Site: Land North of The Rise, Littleworth Lane,
Prepared by: Joe Hitchman
Approved by: Neil Jaques
Date: 27 August 2026

1.0 Document Purpose

1.1 This document has been prepared in response to comments raised by West Sussex County Council (WSCC) in their capacity as Lead Local Flood Authority (LLFA) raised on 20th July 2026 in response to a discharge of condition 13 of planning approval DC/22/0301 (approved on appeal APP/Z3825/W/23/3324144). The full LLFA response is included within **Appendix A** of this document.

Figure 2: Photo taken on site, right image indicating location and direction of photo taken

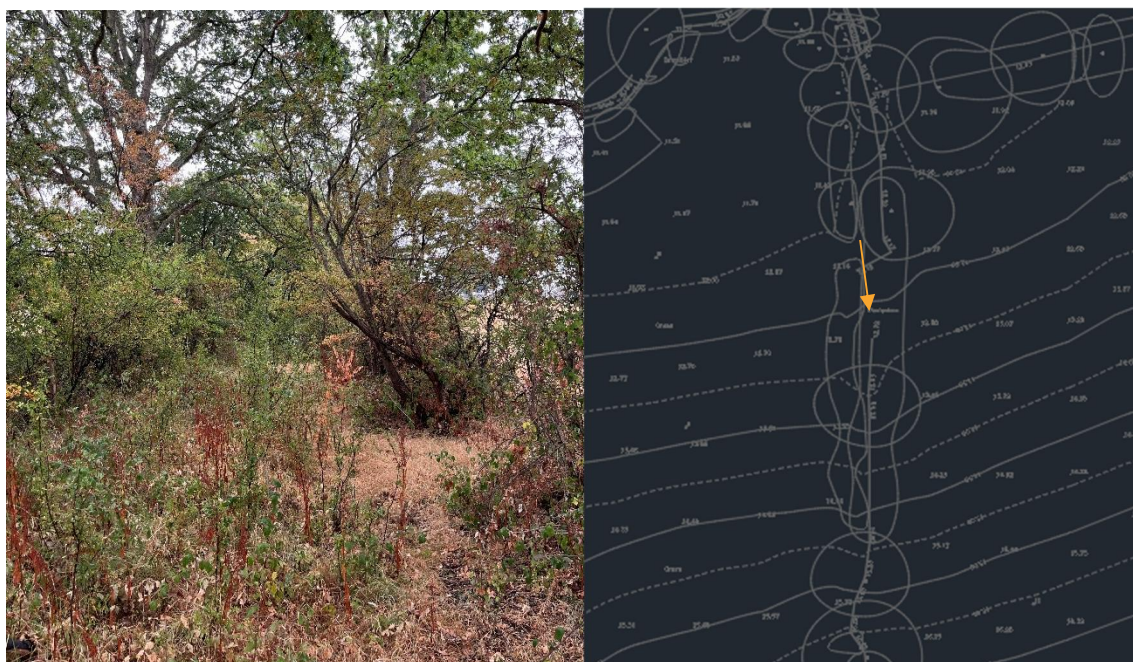
4. *Has the presence of a watercourse in the central South to North vegetated area been discounted? The topographic survey is marked as abandoned in this corridor due to dense vegetation, however historic mapping indicates a field boundary which may have had a ditch connecting to the wider watercourse network. Please can this be investigated if necessary and confirmed/discounted, as any watercourses must be retained including their connectivity.*

- 5.1 In response to receiving this comment, we attended the site to more fully investigate the potential existence of a watercourse at this location. However, we could only observe the tree line, and it does not appear that a ditch exists at this location. Certainly, there is no connection, including piped from the central corridor of trees to the wider watercourse network. Please see image taken from site below.
